TVA-R5-13A+ PCN Report

AN-60-084

COMPARISON PERFORMANCE CURVES^a: $T_{AMB}=25^{\circ}\text{C}$

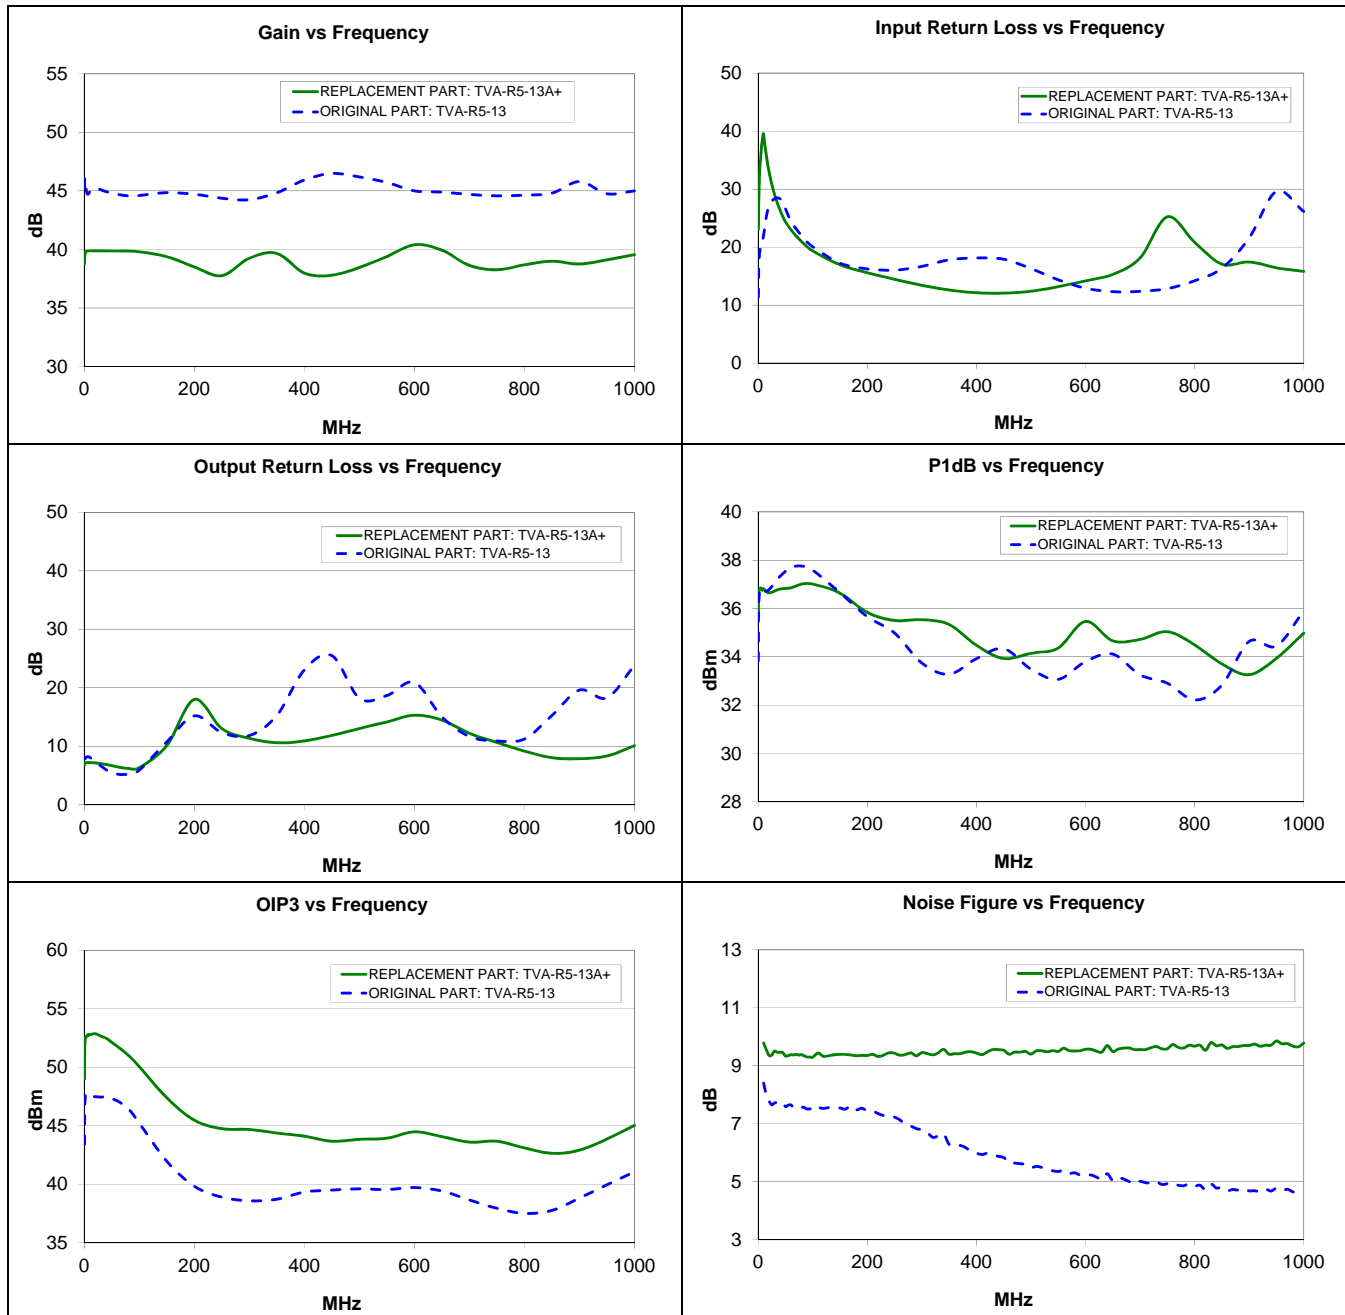
- 1) FIT and FORM change for RoHS version
- 2) FUNCTIONAL changes as follows:

Parameter	Original Part, TVA-R5-13	Replacement Part, TVA-R5-13A+
Gain	35dB min, 41dB typ	34dB min, 38dB typ
Gain Flatness	+/-1.0dB typ, +/-2.2dB max	+/-1.4dB typ, +/-2.2dB max
P1dB	32dBm min, 35dBm typ	31dBm min, 34dBm typ
OIP3	40dBm typ	42dBm typ
Noise Figure	8dB typ	10dBm typ
